## Design change to SAF INTRA steel hanger bracket series:

In the course of continuous product improvement here at SAF-HOLLAND, we will gradually be introducing an improved hanger bracket for the INTRA series from the 4th quarter of 2016. The new design has several advantages with regard to vehicle implementation and the alignment of the hanger brackets on the vehicle frame.

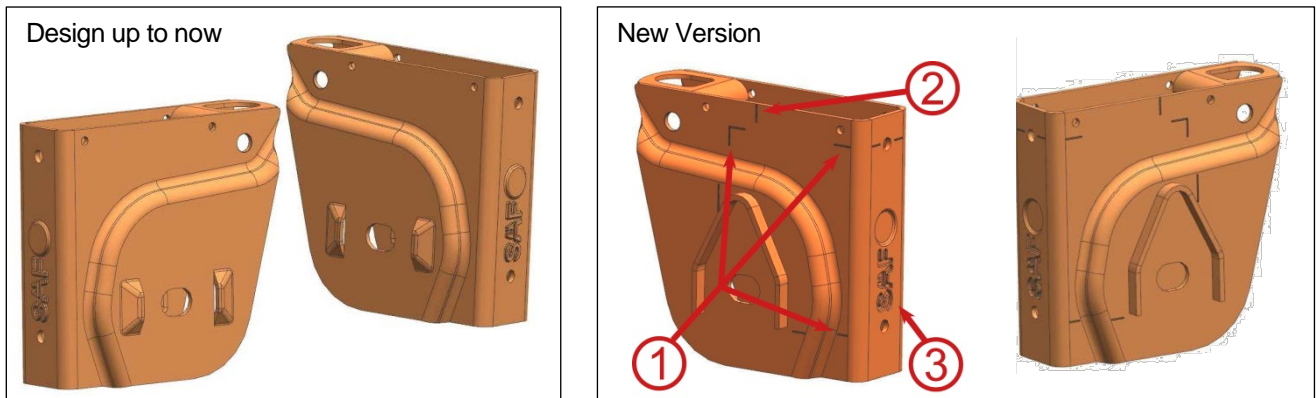
- **New:** 1) Marked area showing where to mount the cross member.
- **New:** 2) Marking of pivot bolt makes positioning easier.
- **New:** 3) Mounting of cross member is made easier by engraved SAF lettering

- Existing paintwork masking can continue to be used.
- Only homogeneous products can be mounted on the vehicle.
- The tightening torques of the spring bearings remain unchanged.
- Please note that there may be an effect on the integration of your cross members (We provide the relevant information).
